WESTINGHOUSE NUCLEAR SAFETY
SAFETY EVALUATION CHECK LIST

- 1) NUCLEAR PLANT(S) : BYRON/BRAIDWOOD UNITS 1 & 2
- 2) SUBJECT (TITLE): RELAXATION OF MSSV SETPOINT TOLERANCE TO +/-3%

BYRON/BRAIDWOOD UNITS 1 AND 2
INCREASED MAIN STEAM SAFETY VALVE SETPOINT TOLERANCE
SAFETY EVALUATION

FIGURE 15.2-2

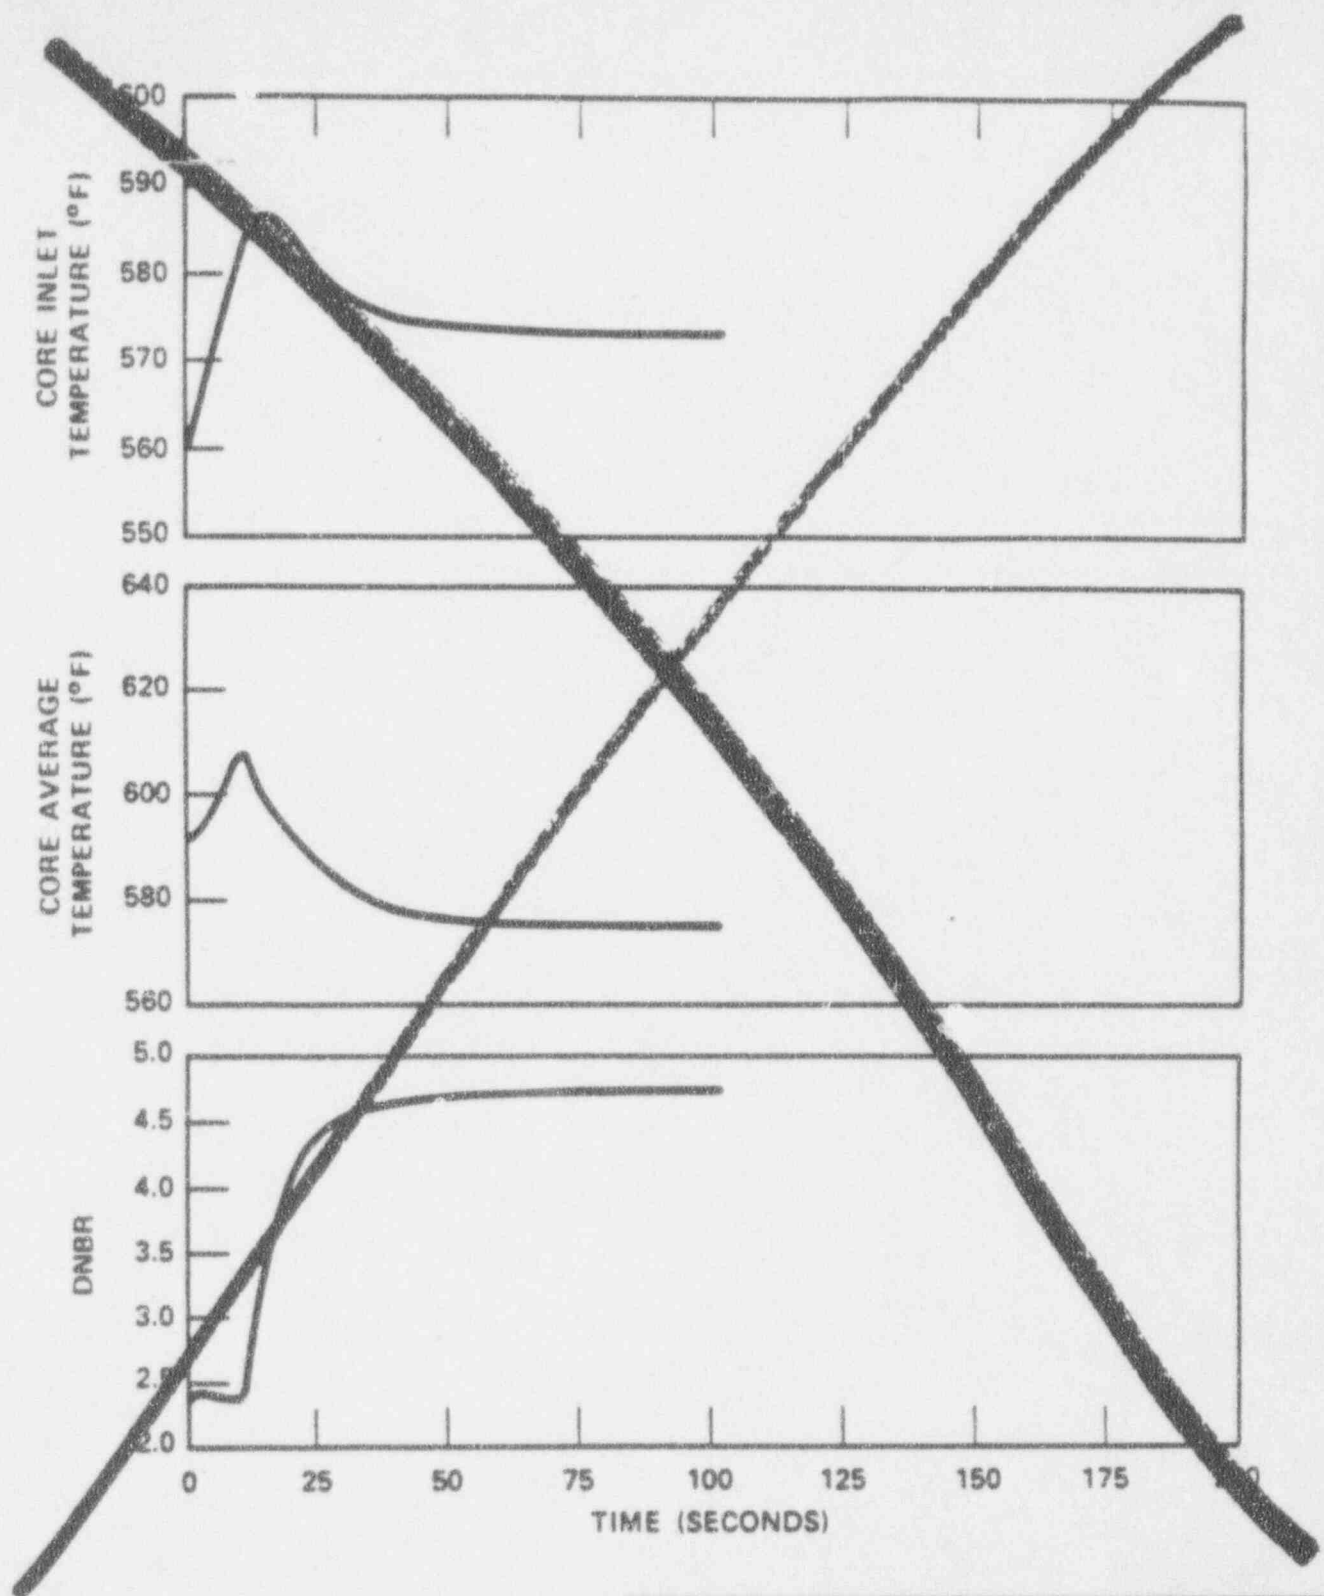
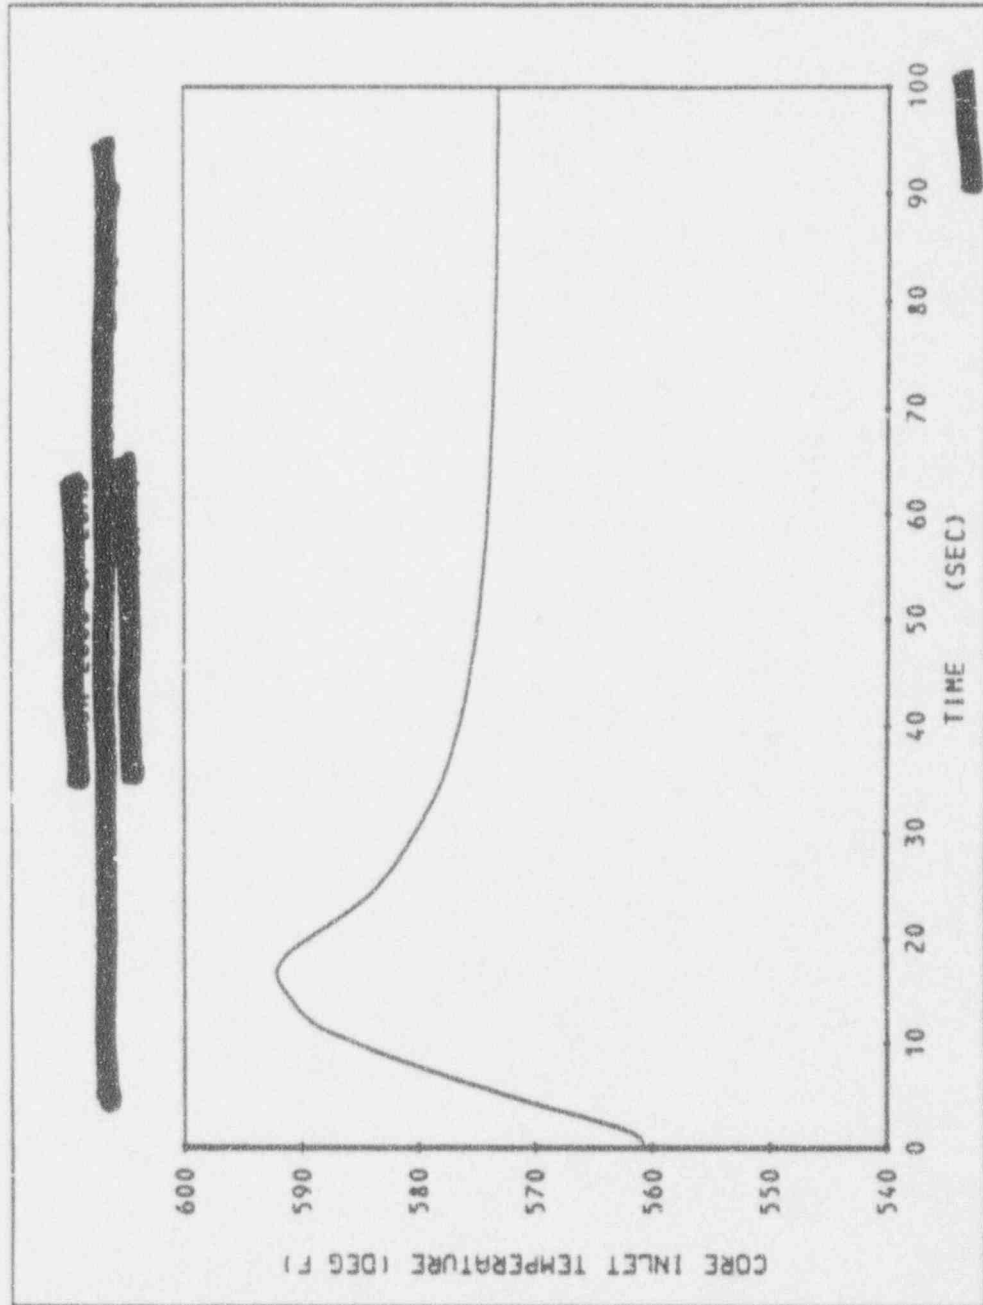
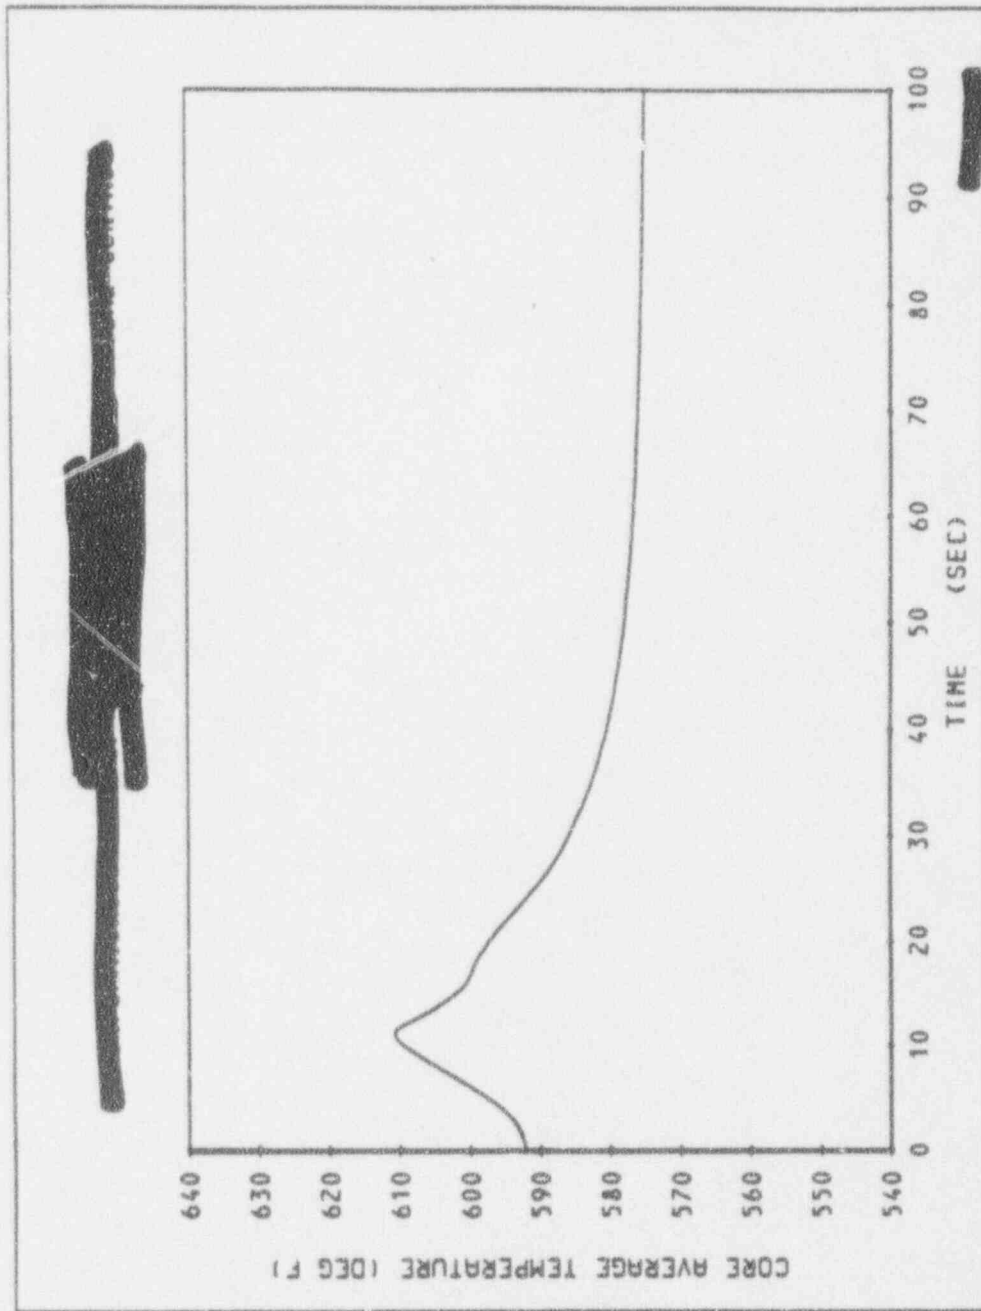
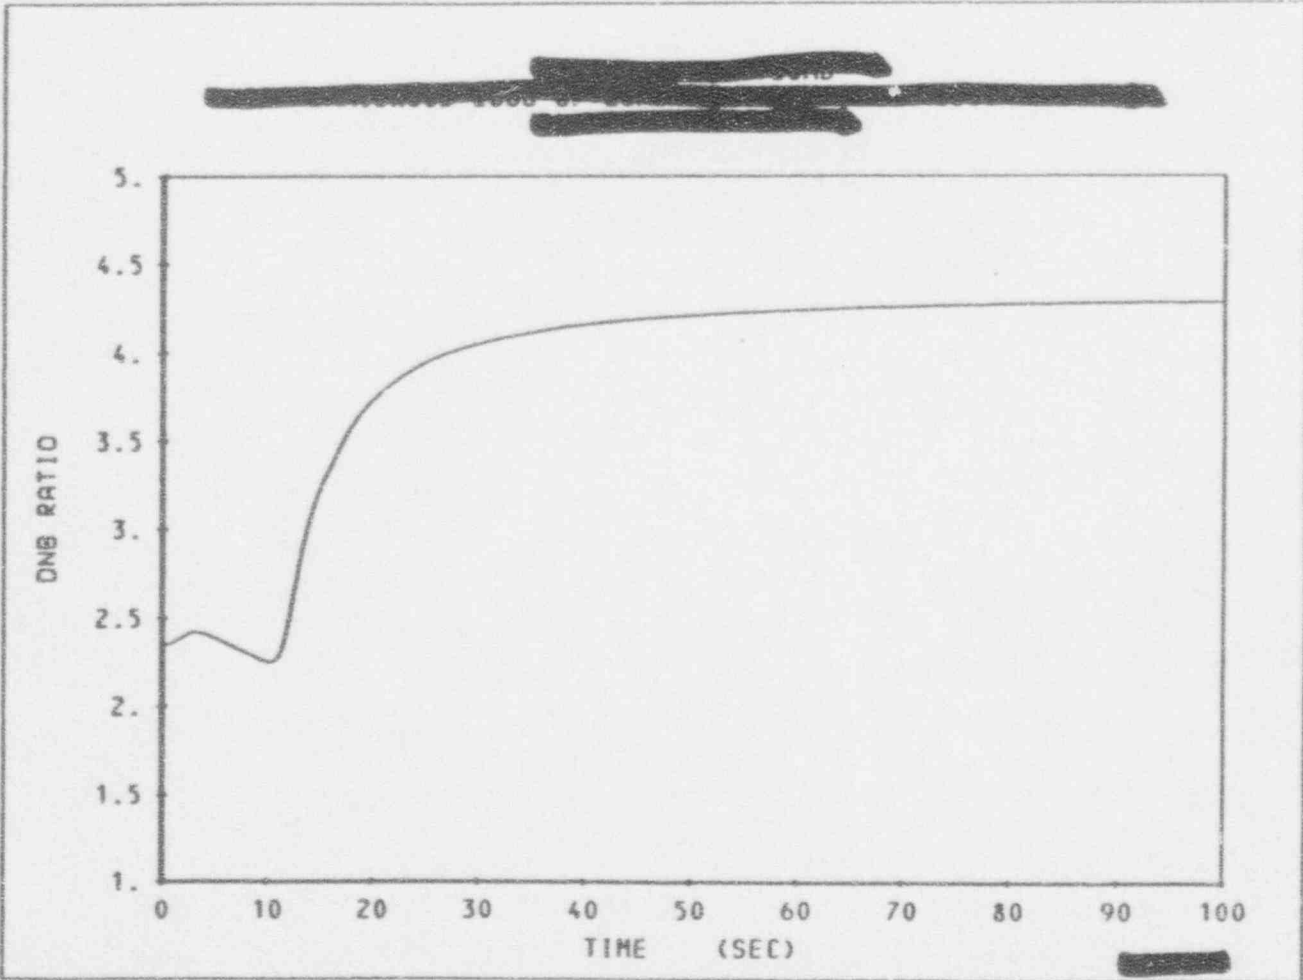
Figures 15.2-1 and 15.2-2 show the transient responses for the total loss of steam load with a least negative moderator temperature coefficient assuming full credit for the pressurizer spray and pressurizer power-operated relief valves. No credit is taken for the steam dump. The reactor is tripped by the ~~high-pressurizer pressure~~ trip channel. The minimum DNBR remains well above the limit value. The ~~pressurizer safety valves~~ are actuated and the primary system pressure remains below the 110% design value. The steam generator safety valves limit the secondary steam ~~conditions to saturation at the safety valve setpoints.~~ pressure to less than 110% of the design value.

REPLACE WITH
The following
Figures
